ASSESSMENT REPORT

North Cooranbong Concept Plan MP 07_0147 MOD 4

This report is an assessment of a request to modify the Concept Plan for the North Cooranbong residential estate in the Lake Macquarie City Council local government area (LGA).

Figure 5: Approved and Proposed Alignment of the Local Road Servicing the Southern Catchment
(Source: Environmental Assessment for MP 07_0147 Mod 4)

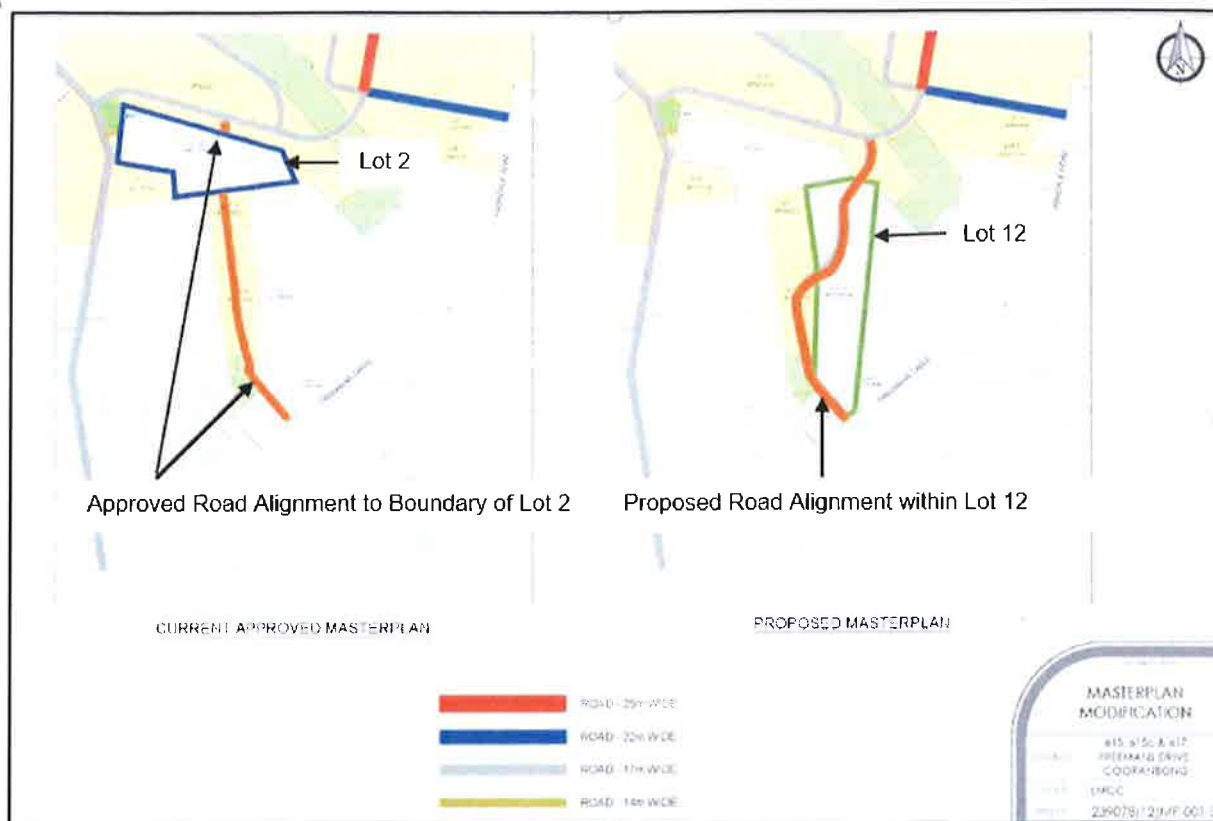
- Council supports the width of the proposed road reserve and carriageway (17 metre (m) wide road reserve and 9 m wide carriageway proposed). However, the Proponent should demonstrate the following design requirements can be met prior to the determination of the modification request:
 - a minimum curved radii of 120 m can be provided
 - the road design speed would not exceed 50 km/hr
- the Proponent should demonstrate how access will be provided to Lot 2.

- the alignment of the proposed local road should be revised to correspond with the boundary of the E2 and R2 zones on Lot 12
- a 30 m wide vegetation corridor should be provided along the eastern boundary of the site to provide consistency with the NSW Land and Environment Court judgement for DA/714/2014
- the proposed development will result in the removal of two plant species listed as 'vulnerable' under the *Threatened Species Conservation Act 1995* (TSC Act) and the *Environmental Protection and Biodiversity Conservation Act 1999* (EPBC Act) and offsets should be provided to compensate for their loss
- all offsets should be calculated in accordance with the OEH's Biobanking Methodology and secured in perpetuity.

- the proposed modification would result in Lot 2 becoming land locked and would also increase the landowner's reliance on JPG to facilitate the redevelopment of this land
- the proposed connection to Freemans Drive should be provided closer to Nellinda Road and the Proponent should pay for upgrades to the existing road network
- the relocation of the waste water treatment plant is not supported.

- the proposed alignment of the revised local road would fragment existing vegetation corridors and reduce connectivity to land on the southern side of Freemans Drive.

- the proposed road alignment has been revised to generally align with the boundaries of the R2 and E2 zones (see **Figure 7**)
- Council and the OEH have advised the proposed offset arrangements would be sufficient to mitigate the impact of additional vegetation clearing on Lot 12. This offset can be obtained via the inclusion of a new assessment requirement for suitable arrangements to be in place to secure the proposed offset prior to the determination of any development application proposing to clear *Tetrahelea juncea* or *Angophora inopina* on Lot 12

Figure 8: Removal of North-South Road to Lot 2 (Source: North Cooranbong Concept Plan RTS)

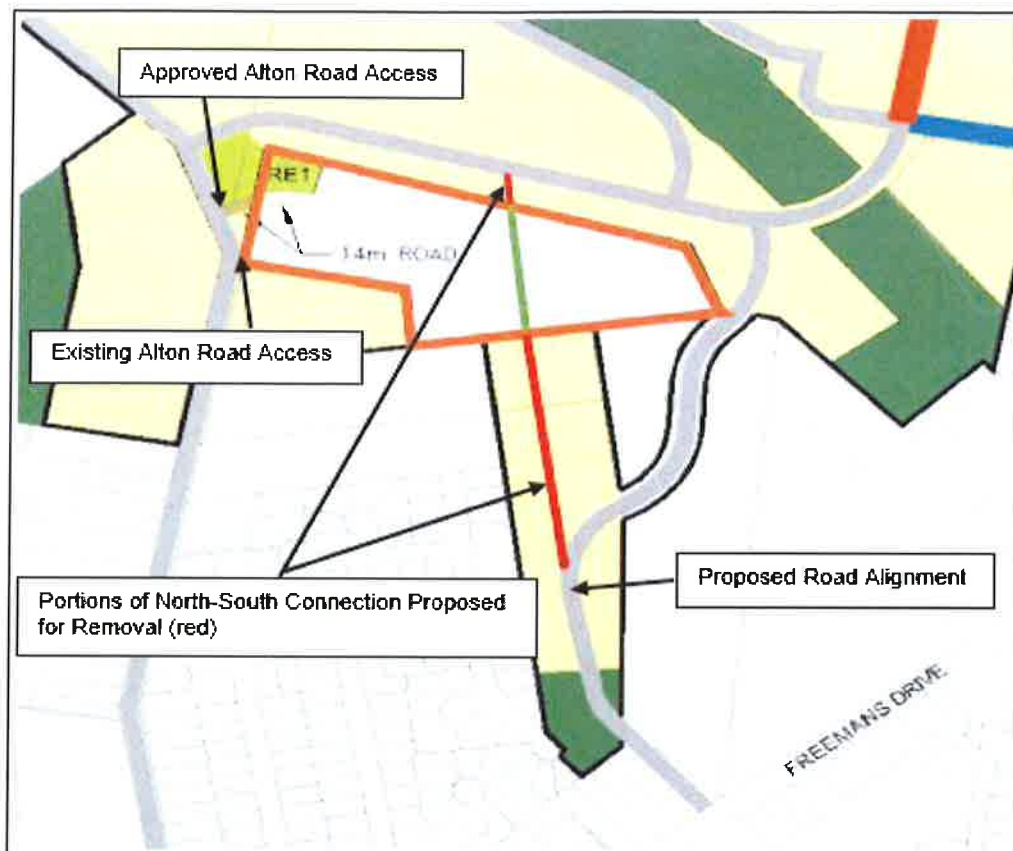
Lot 2 does not form part of the Concept Approval as the owner of Lot 2 did not consent to being part of the original application. The owner of Lot 2 raised concerns about the removal of the north-south road adjacent to Lot 2, as it would:

- remove the opportunity to provide north-south connectivity within and to Lot 2, and reduce the potential design options available for the redevelopment of this lot
- potentially alter the timing for the redevelopment of Lot 2, as the redevelopment of this lot would rely solely on the provision of the road connection adjacent to the western boundary of the site on land controlled by the Proponent.

The Department requested the Proponent address the impacts of the proposed modification on connectivity within and to Lot 2 in its RTS. In this regard, the Proponent advised the removal of the north-south road through Lot 2 would not result in any adverse impacts on the basis that:

- it will not delay the redevelopment of Lot 2, as this lot currently relies on the provision of new access arrangements on land owned by others, and the proposed modification would not alter this arrangement
- whilst the relocation of the north-south road would remove two of the site access points to Lot 2, the proposed modification would continue to provide orderly development in the locality as it would retain the eastern access point to Lot 2 (adjacent to the new park required on Alton Road).

Figure 9: Connectivity Plan (Source: Proponent's Supplementary Information dated 19 July 2017)

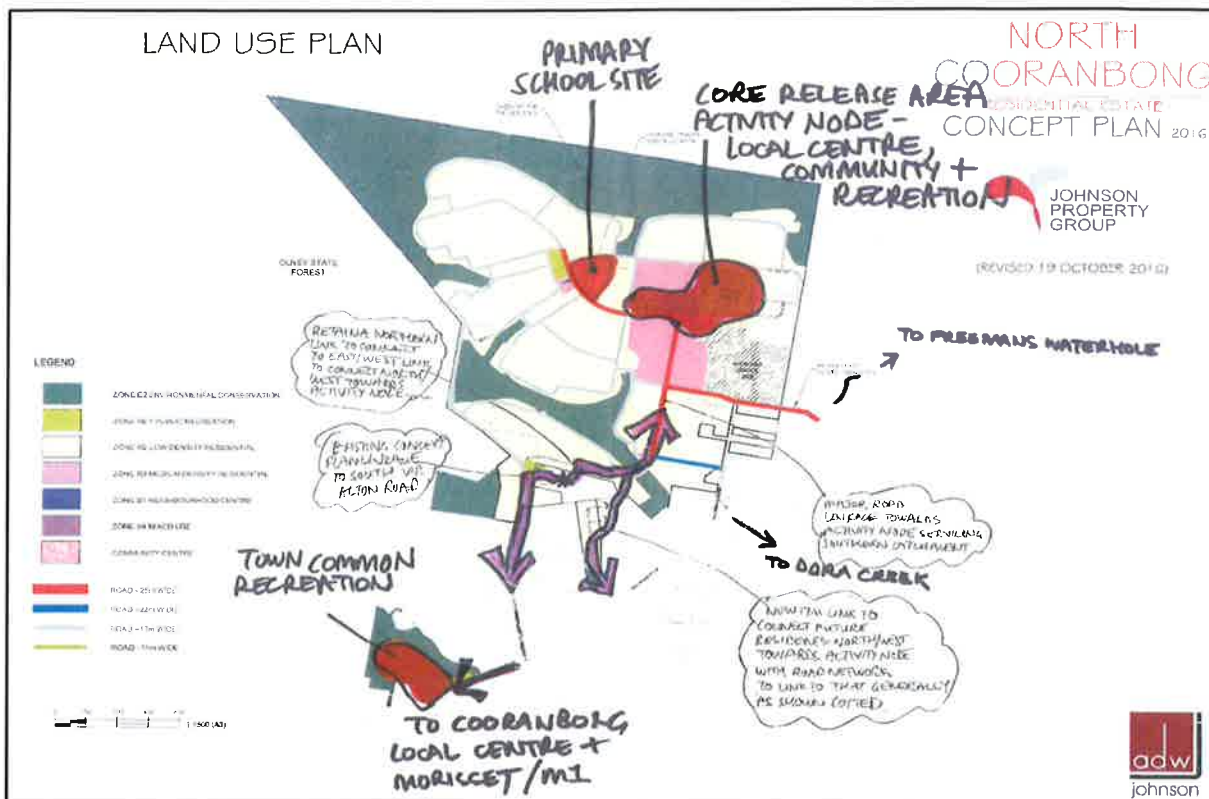
The Department reviewed the Proponent's RTS and requested additional information to demonstrate the relocation of the north-south road would not reduce connectivity within the southern catchment of the site, or adversely impact the redevelopment options for Lot 2. In response to these concerns, the Proponent provided supplementary information on 19 July 2017, advising a second road connection could be provided by condition at the northern boundary of Lot 2 and would achieve the connectivity outcomes identified by the Department. To ensure suitable connectivity is provided to Lot 2, the Proponent suggested modifying the terms of the Concept Approval to require the retention of the road adjoining the northern boundary of Lot 2.

The Department considers the revised proposal, which retains two of the three approved connections, is acceptable as it would provide appropriate levels of access and connectivity and appropriate development options for the future redevelopment of Lot 2. In particular, the Department considers:

- the approved access along the western boundary of the site would provide sufficient access and connectivity to Alton Road, Freemans Drive, the Avondale Shopping Village, Cooranbong and the Pacific Highway/M1 to the south
- retaining a road connection along the northern boundary of the site would provide suitable connectivity to future parks, shops and community facilities located to the north of the site
- removal of the southern access to Lot 2 would not materially impact on the development potential for subdivision of Lot 2 and subject to minor design amendments, would not preclude the delivery of lots in the general configuration identified in the local VPA, (see **Figure 10**).

The Department's assessment therefore concludes, subject to the retention of the northern road connection to Lot 2, the removal of the southern road connection and its replacement with a new road alignment to the east, would provide an acceptable level of connectivity for all lots within and adjoining this part of site. The Department has, therefore, recommended a new modification to the Concept Plan (Modification 2.4) requiring the retention of the access road/access point adjacent to the northern boundary of Lot 2.
